**SUBSURFACE WASTEWATER DISPOSAL SYSTEM APPLICATION**

Town Or Plantation: AUGUSTA

Street Subdivision Lot #: ALBEE RD

Last: PUCCIARELLI First: JOHN

## SUBSURFACE WASTEWATER DISPOSAL PLAN

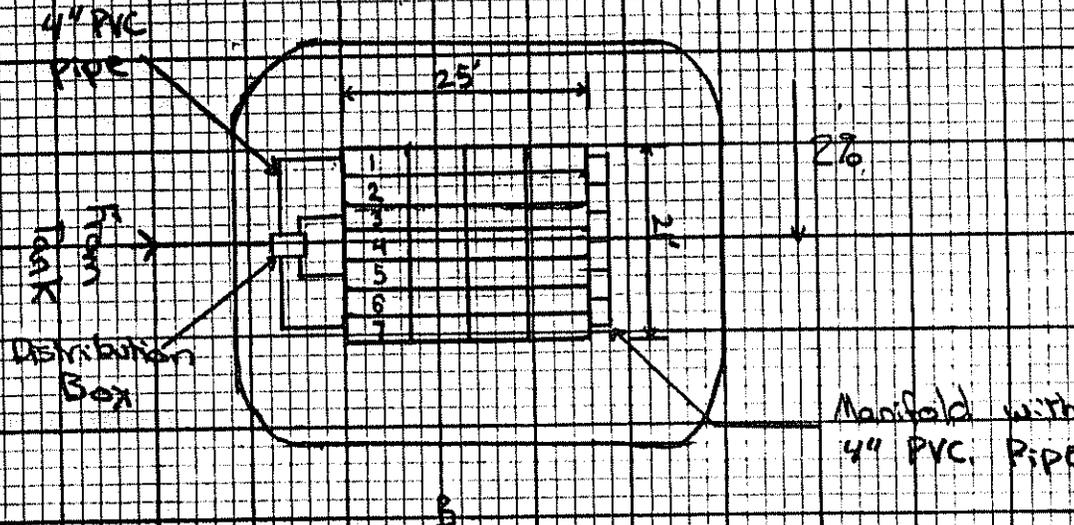
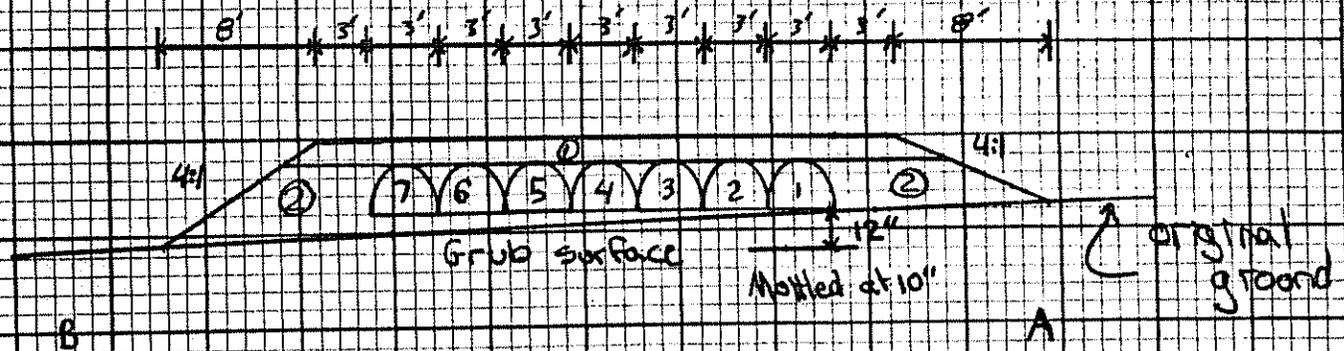
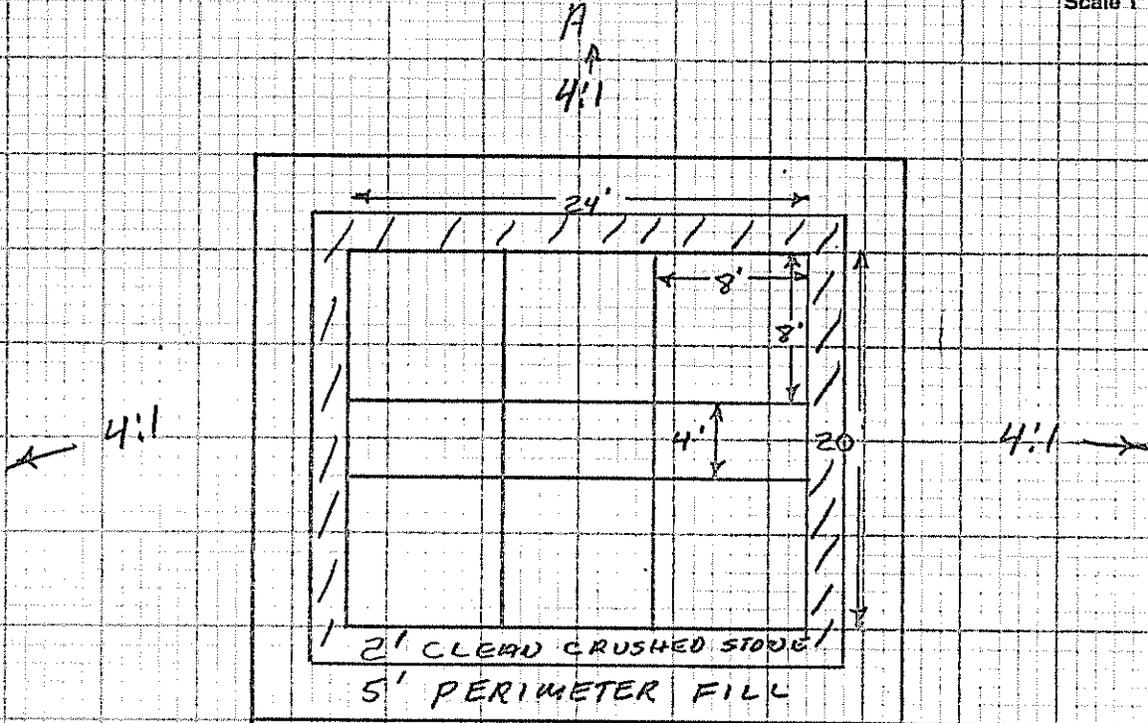
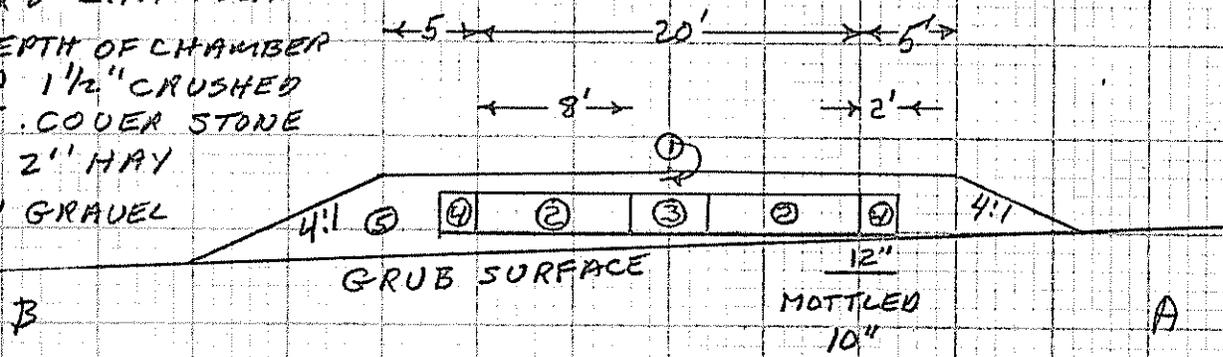
REVISED TO INFILTRATORS BY ECO-TEC OWNER

2nd revision  
Page 3 of 3  
Eco-Tec HHE-200 Rev. 1/84  
6/5/89

28 Infiltrators  
7 rows of 4

- 28 - Infiltrators
- 7 - Rows
- 4 - EA. Row

Depth of Fill (Upslope) 23"  
Depth of Fill (Downslope) 28"

Reference Elevation is 0"  
Bottom of Disposal Area -58"  
Top of Distribution Lines or Chambers -43"

- ① 8" Topsoil Crowned at 3%
- ② Sandy Gravel Fill
